TABS TI Inside Corner Detail over 2" to 3" Insulation

Revised Oct. 28 2026

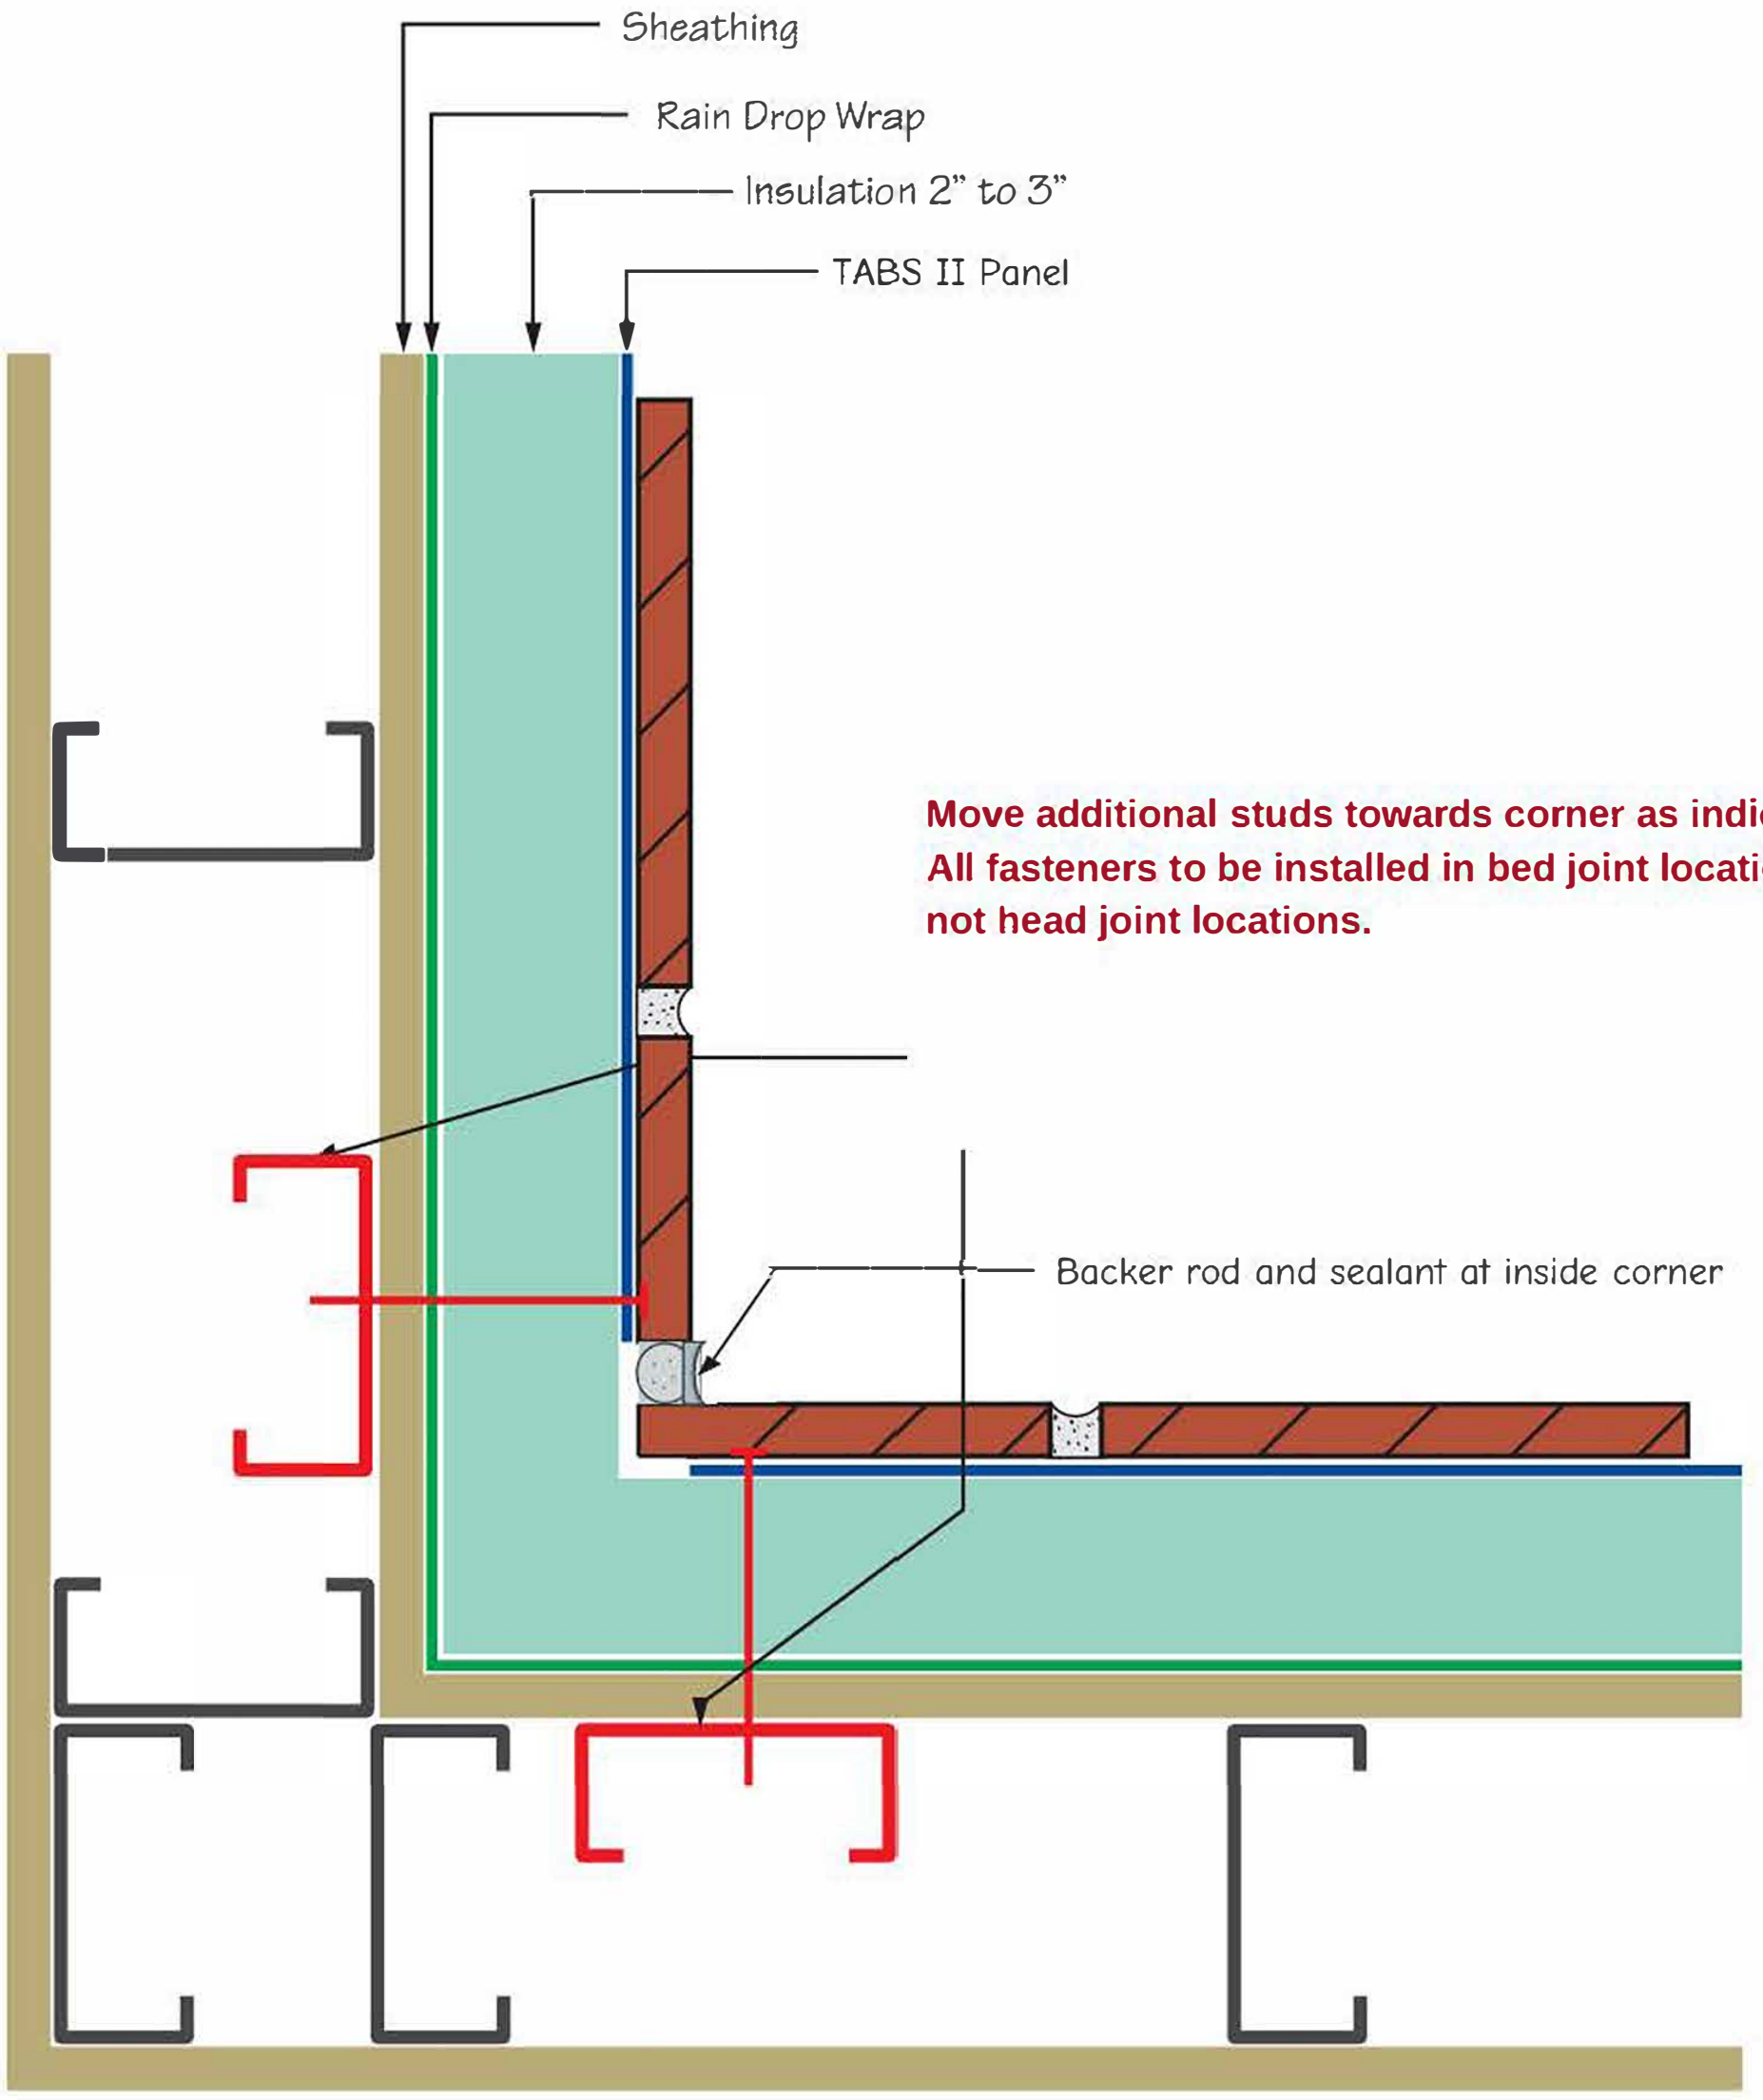
Move additional studs towards corner as indicated.
All fasteners to be installed in bed joint locations, not head joint locations.
